RE/2833 GREAT BRAK RIVER – COMMENTS & RESPONSE TABLE

Mossel Bay Municipality – Water & Sanitation, 12 October 2023

Mossel Bay Municipality – Stormwater, 12 October 2023

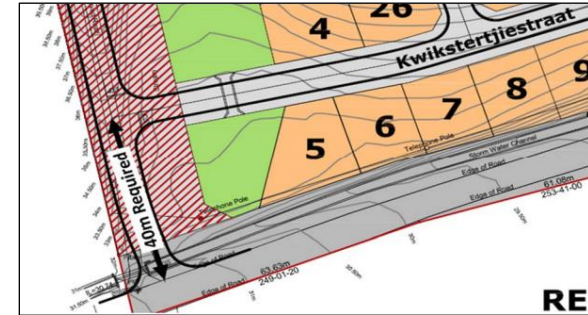
Punt 5, Terloops, ek onthou nie dat iemand vir my gevra het hieroor nie? Die inligting is mos standaard Siviele berekening, itv "Rational Method", die totale opvang gebied van Sandhoogtepad ens. Die kanaal se dwarsnit is min of meer uniform, daar is n helling, dws jul Siviele Ingenieur kan die SW afloop en konsentrasie bepaal, gegewe die helling, en kanaal snit.

- Verder, die SUDS teorie is oulik en als, maar is dit prakties tydens konstruksie, tydens huis verkope, tydens lock & go persele ?
- Gaan die HEV/HOA dit onderhou, gaan daar gereelde onderhoud wees ? Ek sal graag meer detail wou sien rondom die aflope en beheer.

- Stormwater vanaf die 31 Algemene Residensiële Sone I erwe sal suidwaarts na die bestaande stormwaterkanaal aan die suidelike grens van die eiendom dreineer - *Soek berekening, en uitlegte agv topografie.*

- Stormwater vanaf die 12 Enkel Residensiële Sone I erwe sal natuurlik na die laagte punt op die eiendom dreineer - En dan ? groot gat en donga erodeer.

- So gegewe die styl topografie, wil ek graag baie meer detail sien rondom SW beheer, die opvang gebied in geheel van Sandhooite pad versus die bestaande kanaal,

Based on comments received from Mossel Bay Municipality, Urban Engineering arranged a meeting with the Mossel Bay Municipality on **06 November 2023** to discuss the stormwater detail as previously requested (left).

The following points were agreed to:

- Only one access into the site will be allowed.
- Due to the steep road gradient, the weight of construction vehicles to be restricted.
- GLS to provide a report pertaining to the Water reticulation to the site.

- The rational method must be used to determine the pre- and post-development stormwater run-off volumes.
 - Urban Engineering determined a high-level estimate of the expected stormwater run-off for minor (1:5 Year) and major (1:50 Year) storms for the expected catchment area. Based on Urban Engineering's calculations, the introduction of lawns, soft landscaped beds, rainwater harvesting tanks and roads that cut across the general fall of the site, will lead to an increase in time of concentration and subsequent reduction in Peak Flow Volumes (Rational Method)

- To limit stormwater runoff, surface hardening should be restricted to 60% of the erf footprint.
 - The proposed development makes provision for 43 residential units, comprising of a mixture of 2- and 3-bedroom units. The two 2-bedroom unit has a floor area (including garage & patio) of approx.

141m² while the 3-bedroom unit has a footprint of approx. 163m². It can be argued that the total proposed development has the potential to create ~11700m² hard surfaces (dwellings, patios, driveways, garages and internal roads). Since the size of RE/2833 is ~60 400m², it follows that ~20% of RE/2833 will be hardened.
